HOUSTON STRONGER

Houston Stronger Buffalo Bayou & Tributaries Resiliency Study and Interim Report Alternative Review November 18, 2020

FLOODING: THE PRAIRIE SOLUTION

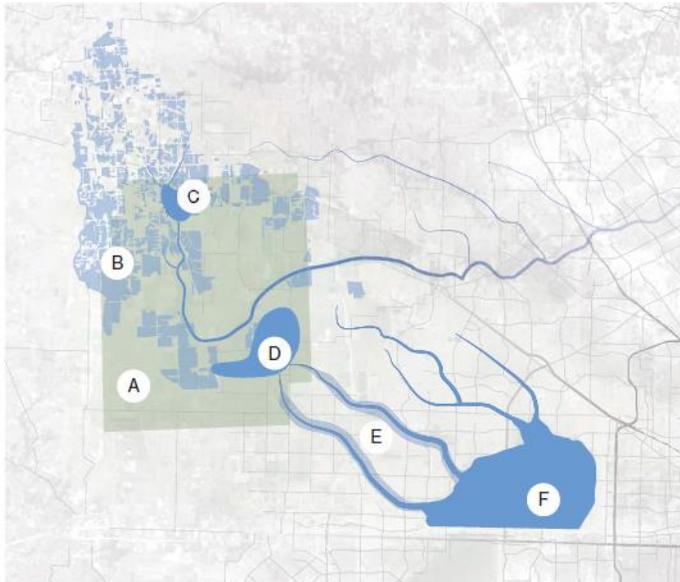
1. **Protect and Restore.** KPC and other conservation organizations propose expanding protected lands from 20,000 acres to 50,000 acres and increasing restored lands to a total of 21,000 acres. The conservation and restoration of these lands will absorb, slow down, and store waters. The tallgrass roots can infiltrate between 6 to 8 inches of water within an hour (in field tests) as opposed to other types of vegetation (pasture, approximately 2 inches per hour and turf grasses, around ½ inch per hour). The tall grasses and other standing vegetation also slow down floodwaters due to the Manning coefficient effect. The natural depressional wetlands store water. The Natural Resources Conservation Service notes that an acre of wetlands can store up to 330,000 gallons of water, the equivalent of filling up Houston’s Astrodome with water. Existing wetlands on KPC-owned lands total 5,000 acres which could mean that more than 1.6B gallons of water could be held which would fill the Astrodome 5,000 times. The expansion and restoration of the prairie could provide an additional 10,000 acre feet of storage.

2. **Permanent Flood Easements.** KPC also recommends implementing efforts to hold water on the prairie studied by HCFCD to acquire permanent easements for detention rights from landowners who agree to reduce runoff on land by creating shallow storage areas by means of low berms. The detention easements would be purchased by HCFCD and would enable the permanent storage of water during flood events. The study was undertaken by Arcadis, a firm with offices here in Houston, that develops projects to reduce flood risk in the United States and internationally. The amount of water that could be stored if the plan is implemented would total 26,000 acre-feet.

3. **Floodplain Acquisition.** KPC also studied the acquisition of floodplains and land along the upper reaches of Cypress Creek where Mound and Snake Creeks come together that could provide further detention benefits. All the proposed activities would also provide additional community benefits such as recreation, wildlife habitat, air and water quality enhancements, local

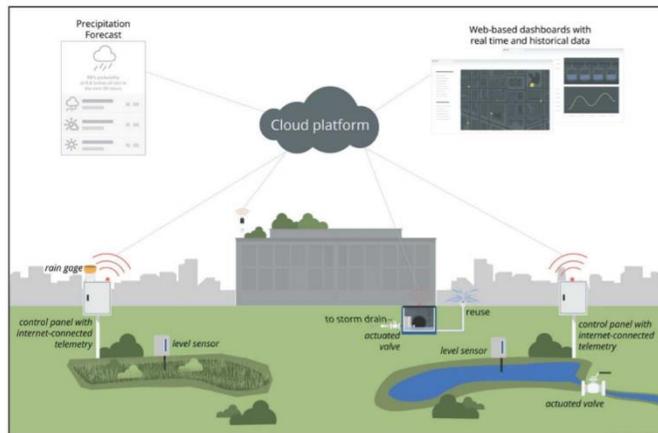
3. **Shorter Tunnel.** While a shorter tunnel will present undesirable social and ecological impacts, reducing its length is an effective way to reduce its cost. USACE could shorten the tunnel by

five miles to the west by moving the initial intake structure to immediately west of Beltway 8 on Buffalo Bayou while improving the Buffalo Bayou channel from SH-6 to BW-8 to convey 15,000 cfs. Buffalo Bayou from SH-6 to BW-8 is an improved channel section and there is an existing drainage easement. This section has significantly more channel capacity than the section east of BW-8, although USACE should consider recreational and environmental benefits of Terry Hershey Park. USACE could shorten the tunnel by 3.5 miles to the east by moving the outlet structure from the Houston Ship Channel Turning Basin (Turning Basin) to immediately east of South Jensen Drive on the east side of Downtown Houston. Few structures between South Jensen Drive and the Turning Basin would be impacted if the water surface elevation is increased. Buffalo Bayou has a wide cross section and is navigable in this reach but subject to severe erosion. The outlet structure should be located to minimize impacts.
